**DOCKET NO: A-98-49
II-B1-17**

TECNICAL SUPPORT DOCUMENT FOR SECTION 194.27:

**SANTOS COMPUTER CODE
IN WIPP PERFORMANCE ASSESSMENT**

**U. S. ENVIRONMENTAL PROTECTION AGENCY
Office of Radiation and Indoor Air
Center for the Waste Isolation Pilot Plant
1310 L St., NW
Washington, DC 20005**

Figure 5. Detail of the deformed disposal room with waste for $f=0$:
at 300 years (Figure 5a) and at 10,000 years (Figure 5b)
(from Stone 1997a, Figures 9 and 10).

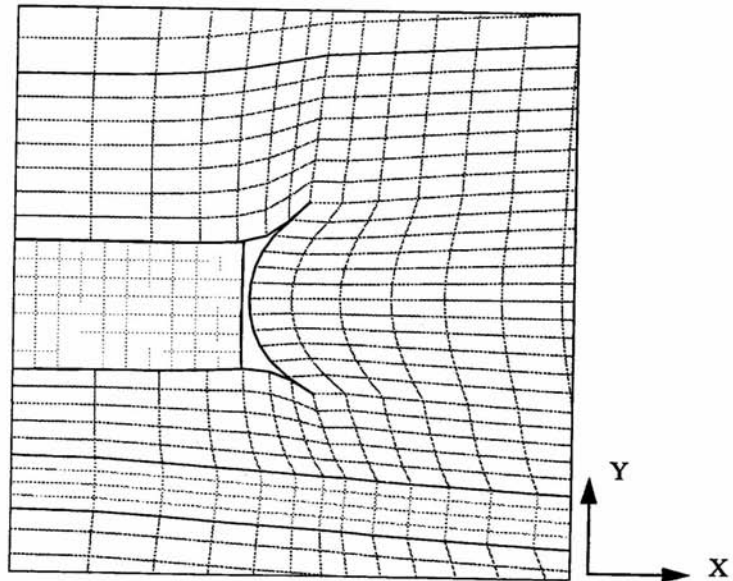
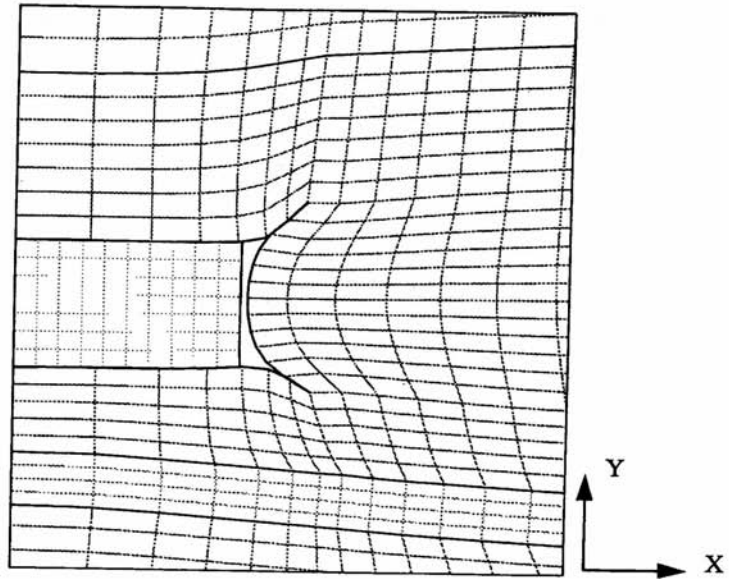
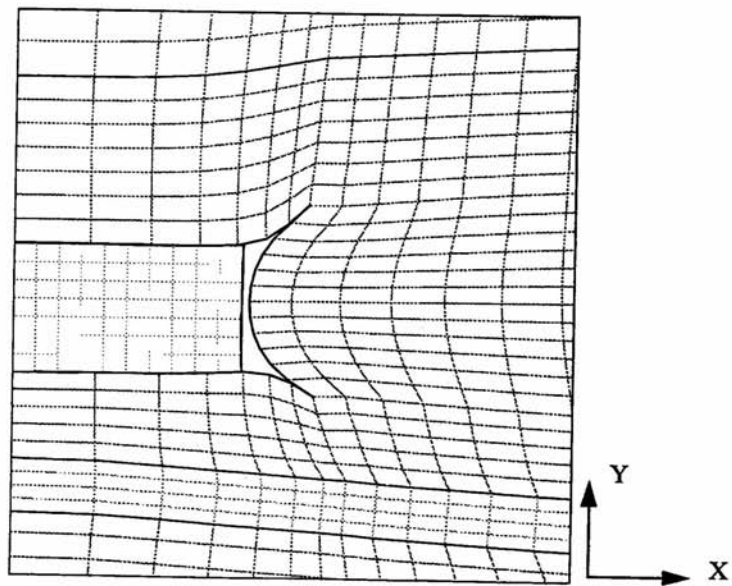
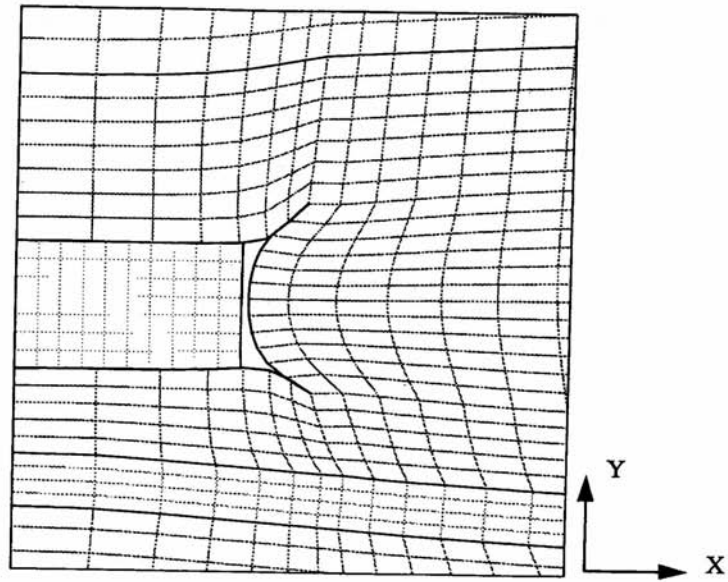
Figures 5a and 5b show the SANTOS-predicted, deformed waste room after 300 and 10,000 years for the case of no gas generation ($f=0$; Stone 1997a, Figures 9 and 10). As shown in the illustrations, the free space around the waste closes relatively quickly. The waste is essentially fully contacted within 300 years and undergoes relatively little subsequent volume reduction. Figures 6a and 6b show the SANTOS-predicted, deformed waste room after 300 and 10,000 years for gas production at half the reference case rate ($f=0.5$; Stone 1997a, Figures 11 and 12). Here the gas pressure becomes sufficiently high to allow essentially no further waste volume reduction after 300 years, and to reduce horizontal wall deformation to the point that no significant horizontal back pressure is provided by the waste for 10,000 years. This suggests that waste porosities can remain high and stresses on the waste can remain low when gas is produced in the repository.

EPA's principal accuracy issue with SANTOS is the relatively low mean stress exerted on the waste when no gas is generated, even after 10,000 years when halite creep should have caused the stress to more closely approach a lithostatic state. This low stress has resulted in higher porosities for the waste than would be expected. Several factors, discussed below, are believed to have caused this condition.

Low Vertical Stresses. The vertical stress on the waste along the centerline of a waste room with no gas production was predicted by SANTOS to be about 12 MPa after 10,000 years (Park 2005). This is somewhat but not excessively less than the lithostatic stress of about 15 MPa. The less than lithostatic vertical stress is likely due in part to the same types of modeling constraints that reduce the predicted horizontal stress, but the impact is less because of the vertical direction of the lithologic load and the wider span of the roof. This allows the roof to contact the waste sooner and results in an earlier buildup of back pressure. As previously noted, final equilibration of the halite with waste room pressure is predicted by SANTOS to proceed slowly.

Figure 7. Pressure histories for various values of the gas generation parameter f (from DOE 2004, Appendix PA, Attachment PORSURF, Figure PORSURF-3).

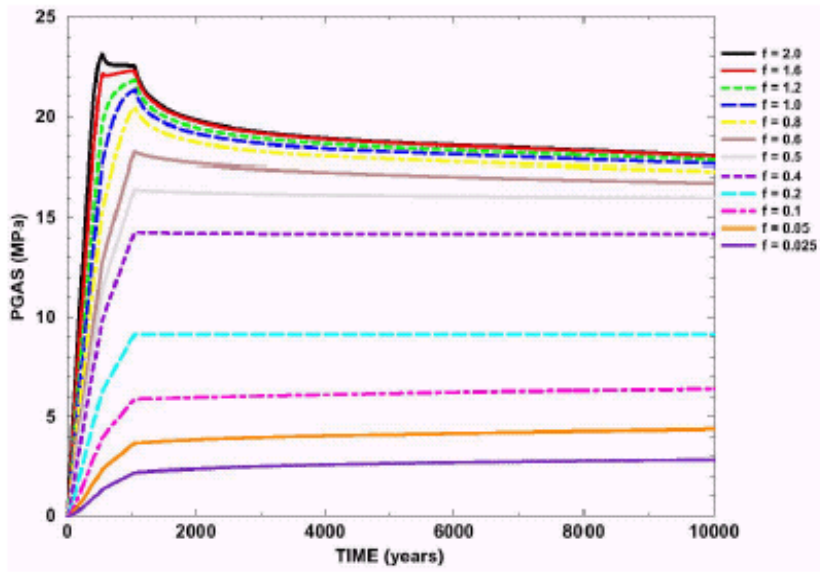
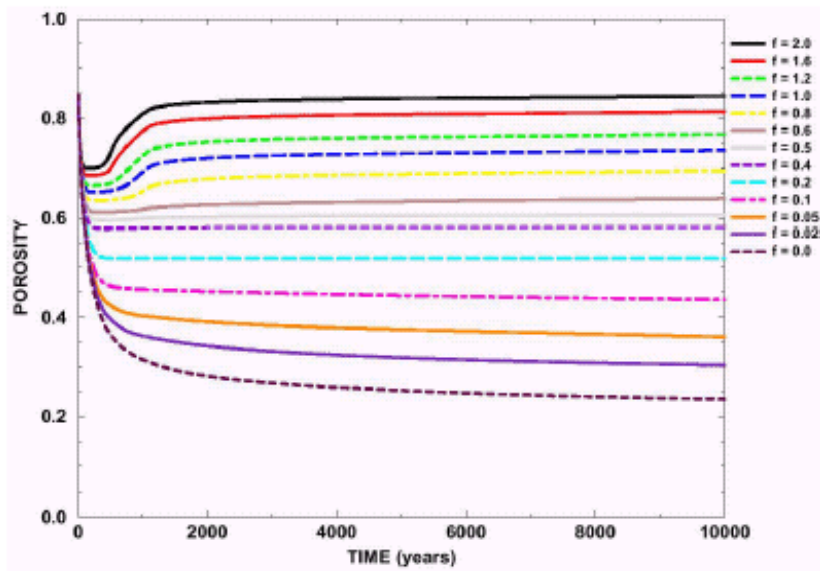
The foregoing conclusion is supported by the results on Figures 7 and 8. For purposes of generating the porosity surface, gas production in SANTOS is assumed to cease after 1,050 years (Stone 1997a, p. 4). Figures 7 and 8 show that for $f=0.5$, after about 1,000 years the waste room gas pressure remains relatively constant at about 16 MPa and the porosity remains approximately constant at about 0.6. This gas pressure is more than sufficient to support the lithostatic pressure of about 15 MPa (F.D. Hansen et al 2003, Section 4.5). Of greater interest is the predicted porosity, shown in Figure 8, of about 0.235 after 10,000 years with no gas production ($f=0$). Considering the aforementioned initial waste porosity of 0.681, a reduction to 0.235 represents a volume strain of about 0.87. From Figure 1, this strain is equivalent to an average applied pressure of about 4 MPa, which is less than the lithostatic equilibrium pressure of about 15 MPa. This indicates that average stresses on the waste are predicted to remain well below lithostatic after 10,000 years, even with no gas pressure in the room. It is also noted that for the higher gas generation rates, generally for $f>0.5$, the porosity history curves in Figure 8 show an increase in waste room porosity between about 500 and 1,000 years corresponding to room dilation.

The SANTOS model predicts that the waste room will inflate (expand in volume) when the internal gas pressure exceeds the lithostatic stress (Stone 1997a, p. 17). Although waste room dilation is not necessarily interpreted as equivalent to expansion of the waste because waste room porosity is calculated as the ratio of the free room volume to the total room volume, room dilation is accompanied by a calculated increase in room porosity. Waste room dilation is represented in the porosity surface and is carried into WIPP performance assessment through the BRAGFLO code. However, unlike SANTOS, maximum gas pressures in BRAGFLO are limited by escape of gas from the waste room by pressure-induced expansion of existing fractures or creation of new fractures in the anhydrite interbeds (DOE 2004, p. 6-103). As a result, gas pressures in BRAGFLO do not significantly exceed the lithostatic stress of 15 MPa.

Figure 9. WIPP convergence plots for E790 Drift-S2350, Room 3, Panel 2
 (from TEA 2005; *SANTOS and Porosity Surfaces*, meeting handout by Bill Thompson, Golder Associates)

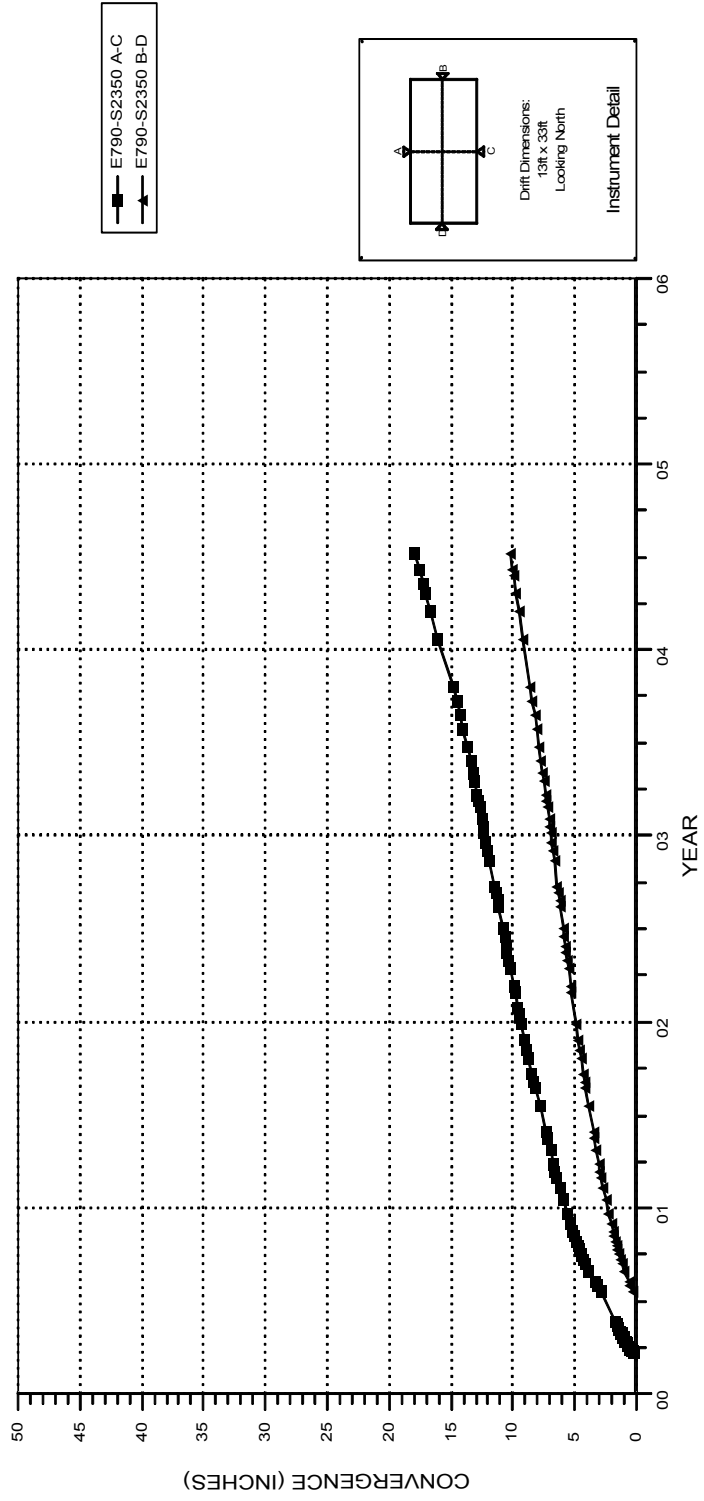
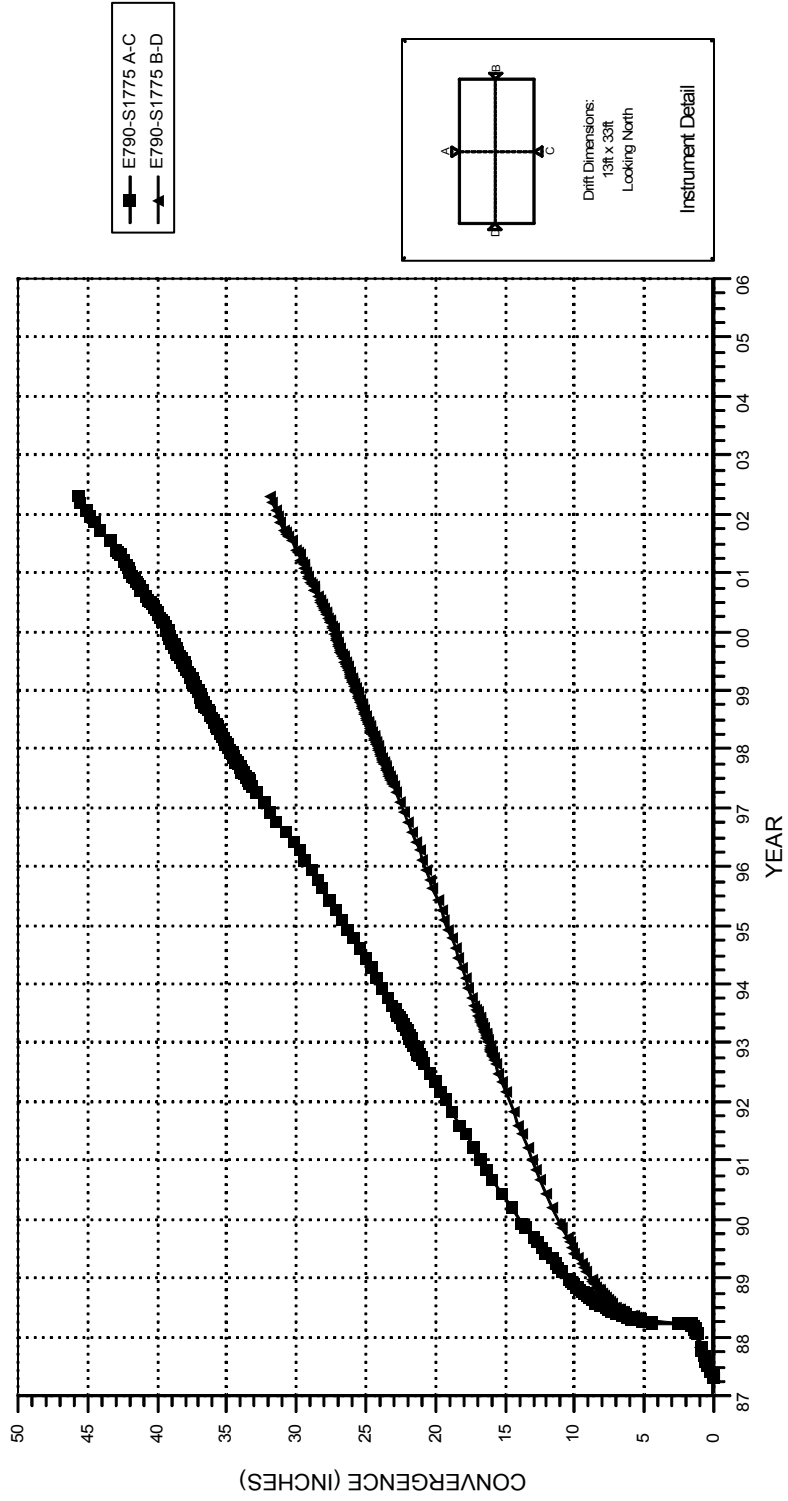
The foregoing considerations suggest that horizontal wall movement into the room would be less rapid than vertical roof and floor movement, even at early times. This expectation has been confirmed by convergence measurements in test drifts at WIPP, as illustrated by Figures 9 and 10 (EPA 2005, *SANTOS and Porosity Surfaces*, meeting handout by Bill Thompson, Golder Associates). The greater span of the roof and floor and the compounding effects of model element contact in the corners of the room provide an adequate qualitative explanation for the SANTOS model prediction of a lower horizontal stress in the walls, however the true magnitude of that stress and the accuracy of the related long-term, secondary halite creep rate after 10,000 years remain uncertain. Although the WIPP field measurements confirm the predicted short-term creep behavior of the halite, they do not address the accuracy of the very slow, long-term rate of return to a lithostatic stress state predicted by SANTOS. The conceptual model of a fairly rapid rate of return to lithostatic equilibrium conditions appears to have been based on recent and historic observations of room closure and halite encapsulation occurring within time frames of tens to hundreds of years and the assumption that the observed closure is accompanied by an equally rapid return to equilibrium stress conditions. However, the room closure observations have not been accompanied by in situ stress measurements and the rate of stress buildup accompanying room closure is therefore uncertain.
